Architectural Review
and Historic Preservation Board
Agenda Report

File : AR 17-08

RE: Architectural Review 17-08 (Fountain Residential Partners)
322, 328, 332 Nord Avenue; APNs 043-230-006, -007, -008

CIVIL SITE PLAN

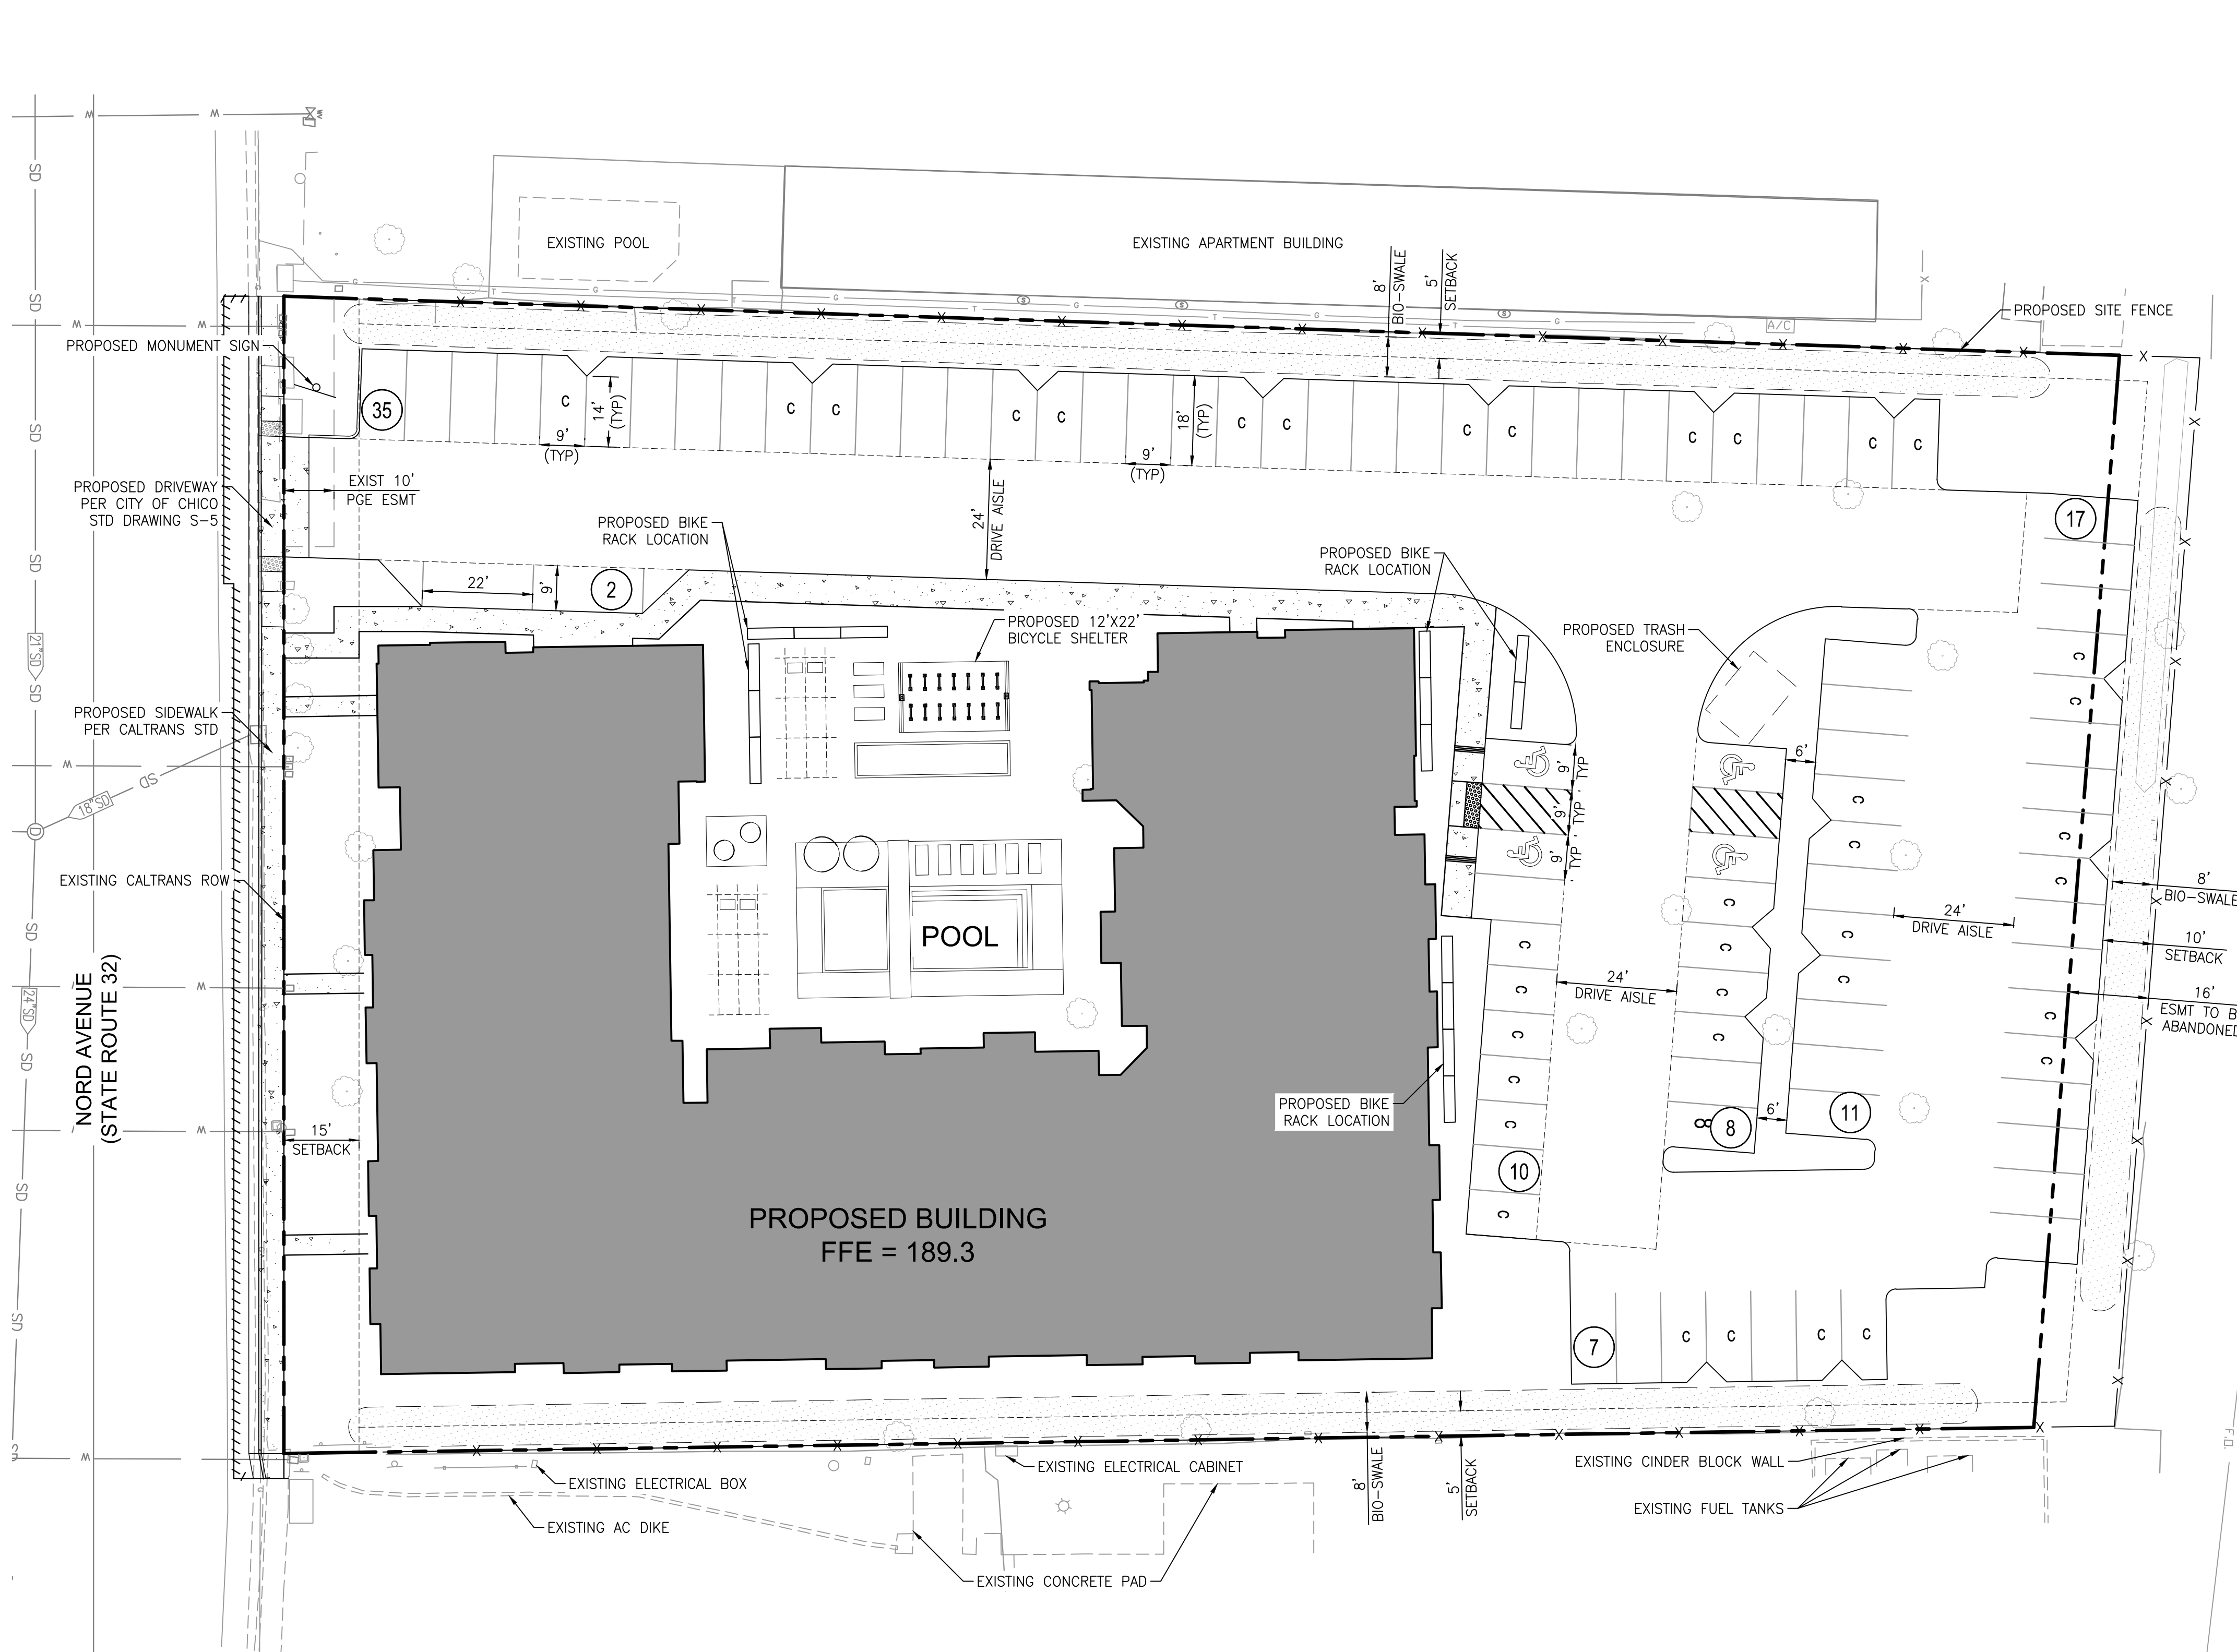
Lighting: Discuss the specific location of all light fixtures and lamp intensities. Determine if adequate light is proposed in the parking area, particularly for security purposes given the sites proximity to the bike path, CSUC campus and the railroad tracks.

The proposed site plan indicates 2 parking lot light fixtures at an unknown height, and 8 wall mounted light fixtures on only three sides of the building; no lighting is proposed on the buildings south elevation. For reference, Chico Municipal Code 19.70.060.F provides that parking light lighting shall be "capable of providing adequate illumination for security and safety". DG 4.1.53 encourages safe and secure parking areas through appropriate lighting.

PRELIMINARY LANDSCAPE PLAN

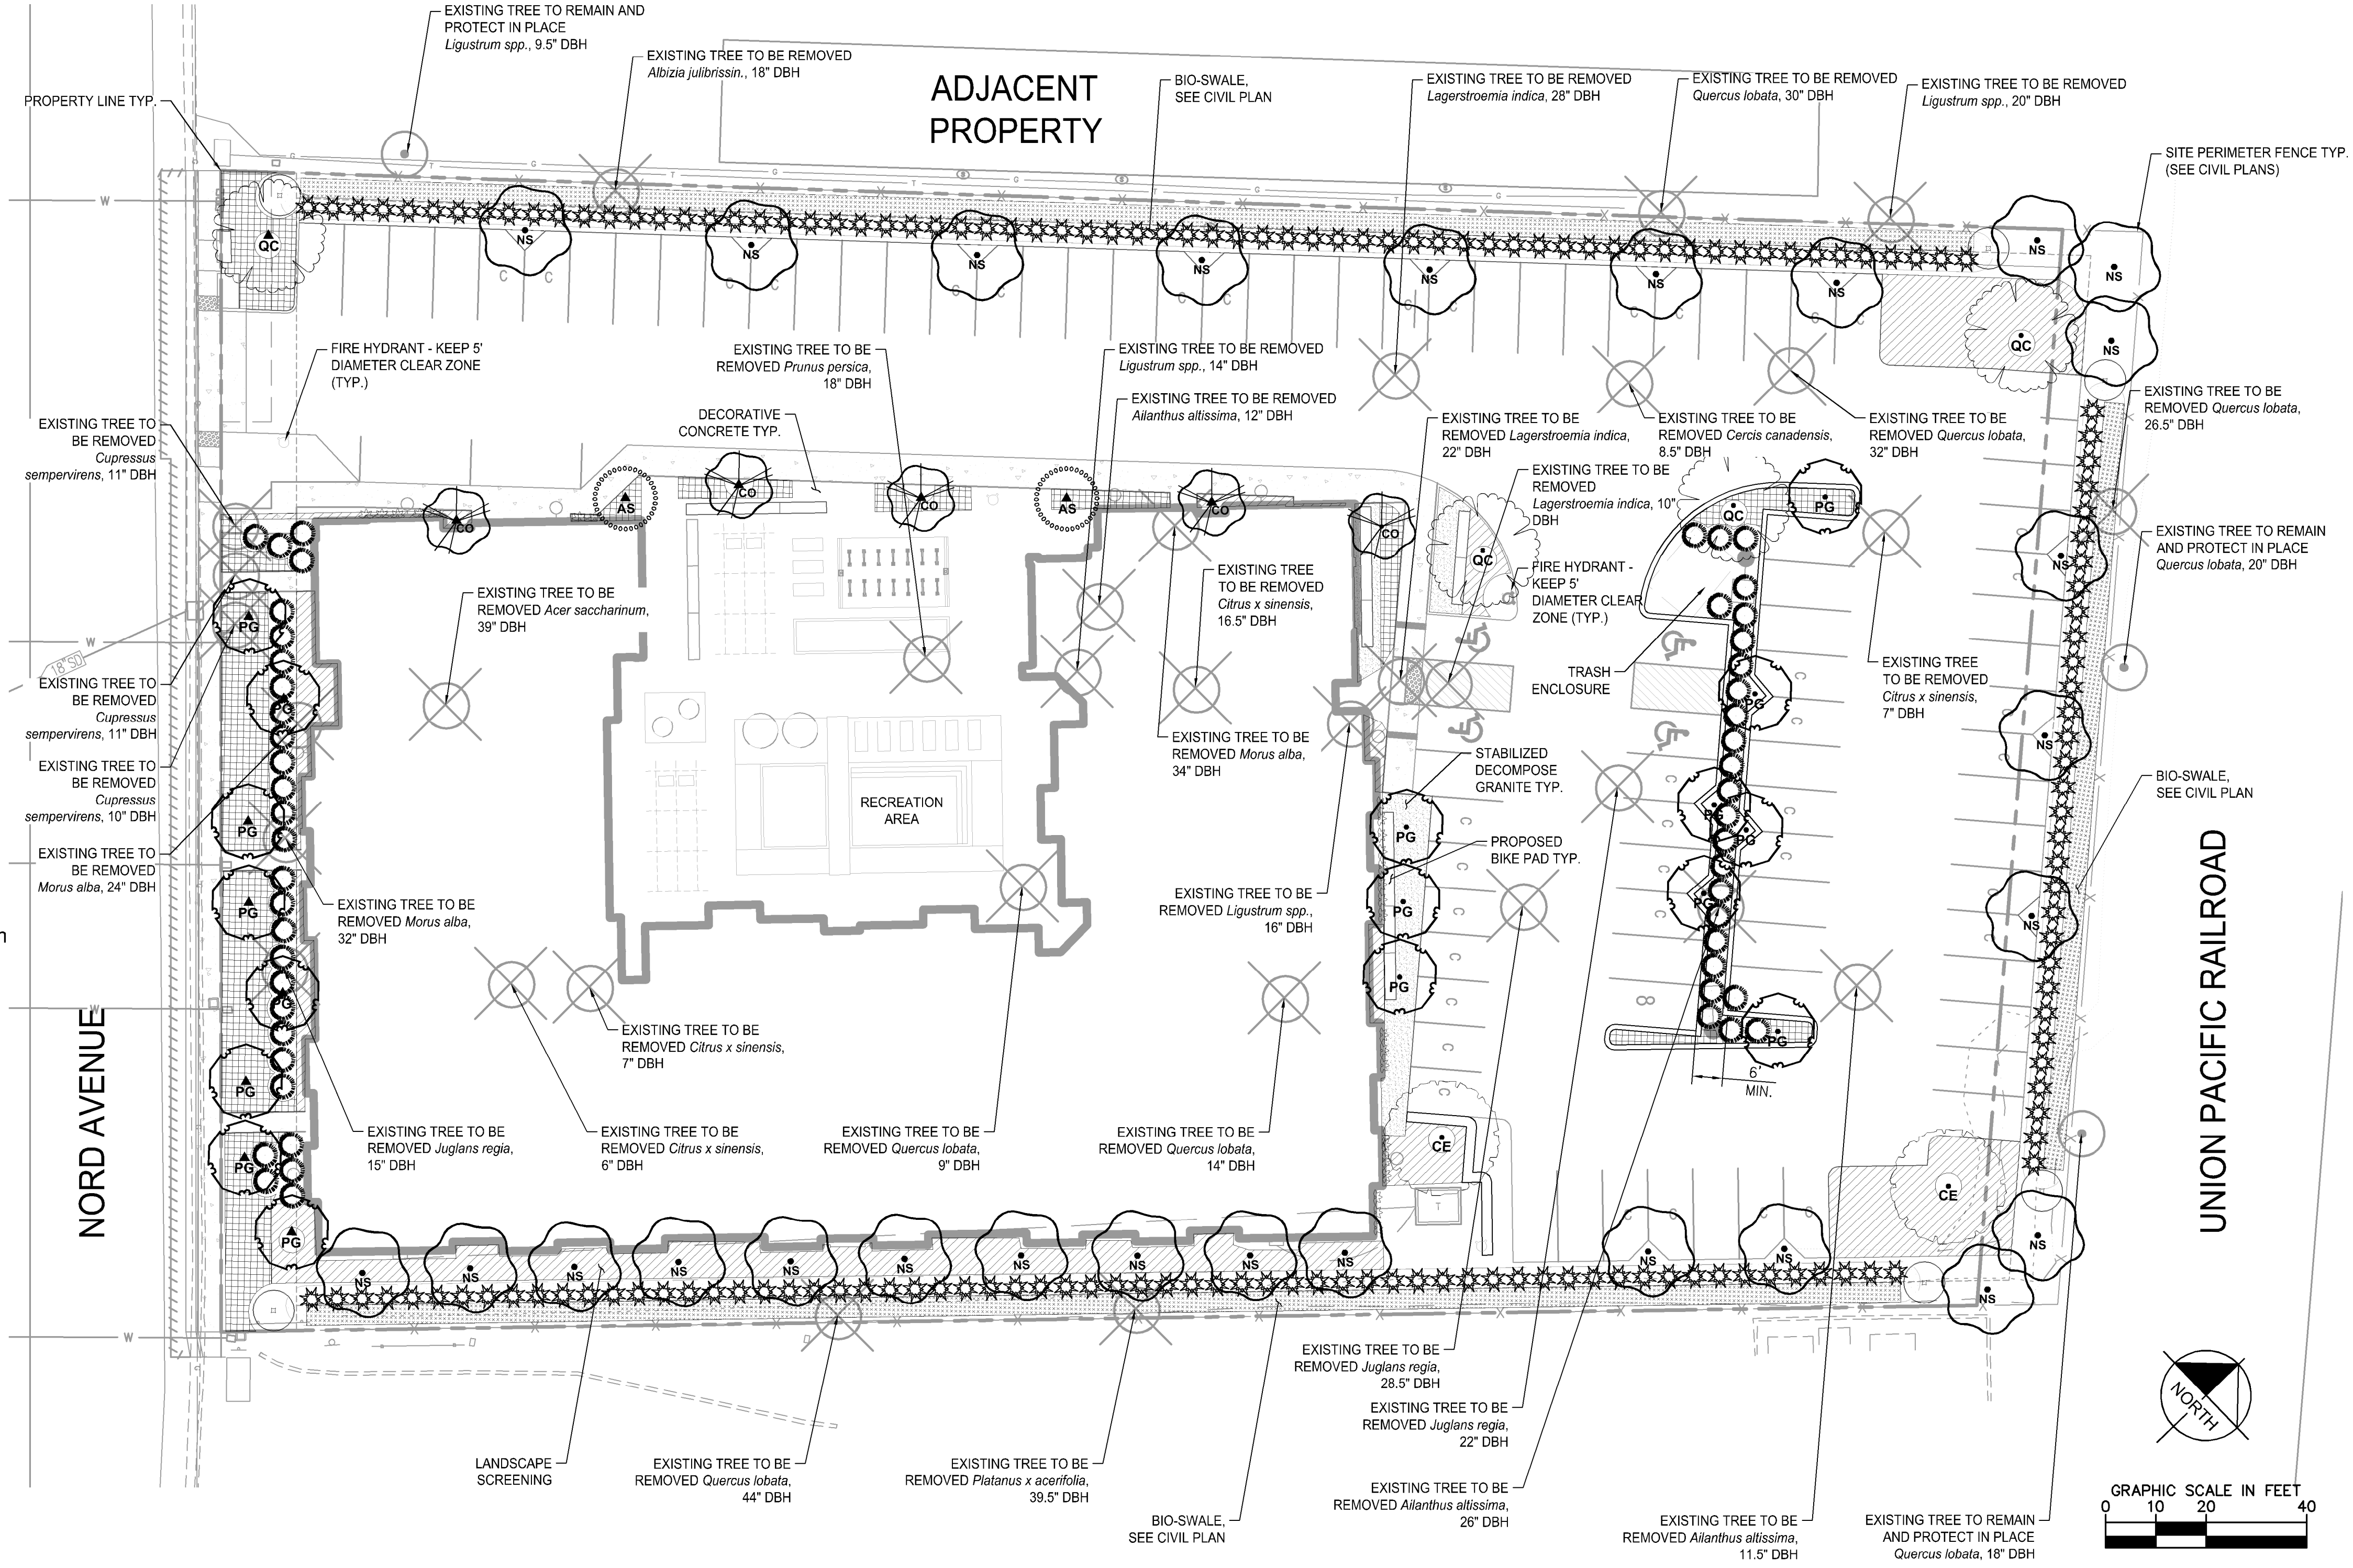
1. All approved building plans and permits shall note on the cover sheet that the project shall comply with AR 17-10 (Fountain Residential Partners).
2. All wall-mounted utilities and roof or wall penetrations, including vent stacks, utility boxes, exhaust vents, gas meters and similar equipment, shall be screened by appropriate materials and colors. Adequate screening shall be verified by Planning staff prior to issuance of a certificate of occupancy.
3. The final landscape plans shall indicate creeping vines against trash enclosure stucco walls.
